Subject: Recall Campaign ref: L147.R-01.03
Upper Steering Column Shaft Coupling

Procedure: L147.R-01.03

Operation: Instructions for upper steering shaft coupling bolt torque verification

Fig. 1

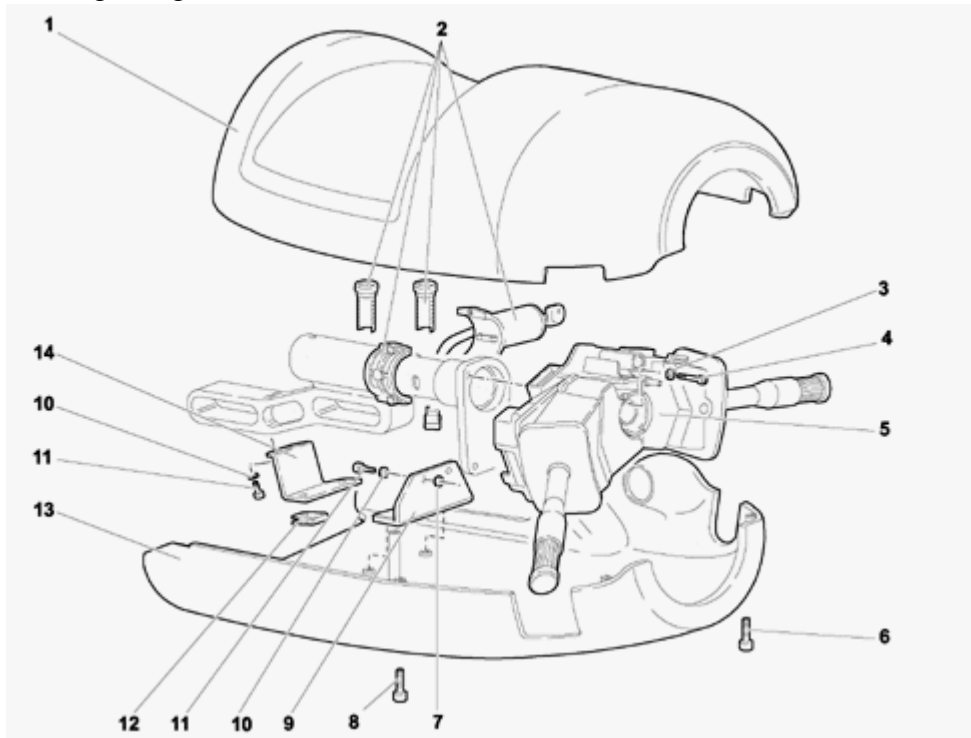
- 1.1 Remove the lower cover (13) removing the attaching screws (6) and (8) referring to Figure 1.

Fig. 2

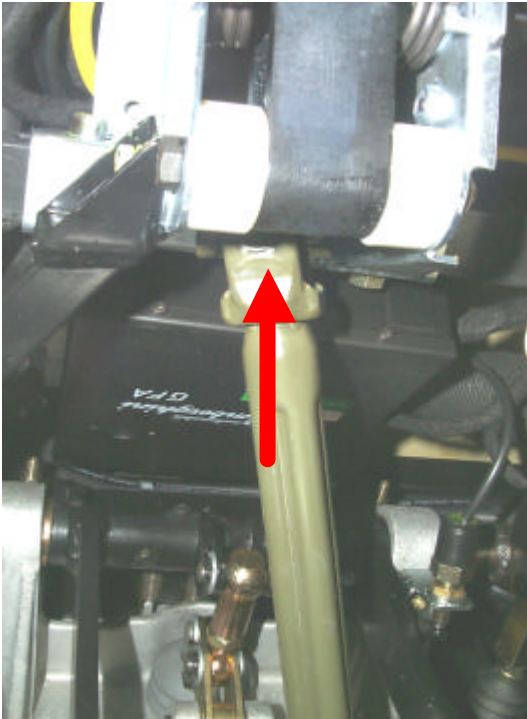
- 1.2 Proceed from underneath the steering column, locate the Upper Steering Shaft Coupling Bolt referring to Fig. 2.

Fig. 3

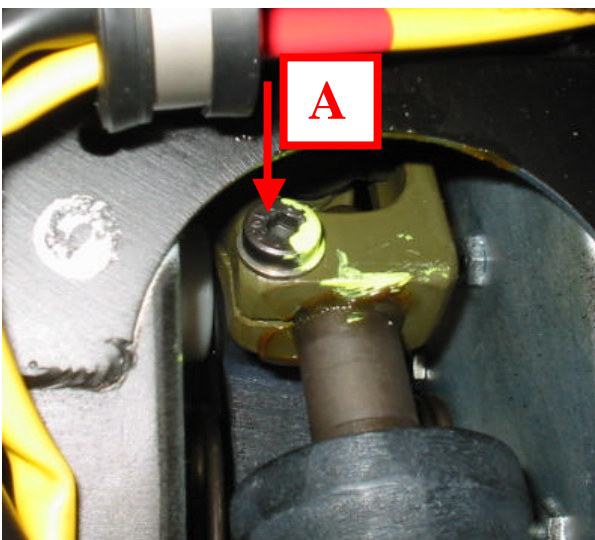
- 1.3 Tighten the bolt (A) of the Upper Steering Shaft Coupler show in Fig. 3 between the steering shaft and the steering column using a torque wrench to 27 Nm or 20 ft.lbs. (with a tolerance of $\pm 5\%$).

- 1.4 After tightening the bolt, mark with yellow paint. See Fig. 3.
- 1.5 Install Recall Completion Sticker on lower side of driver's door above VIN Conformity label.
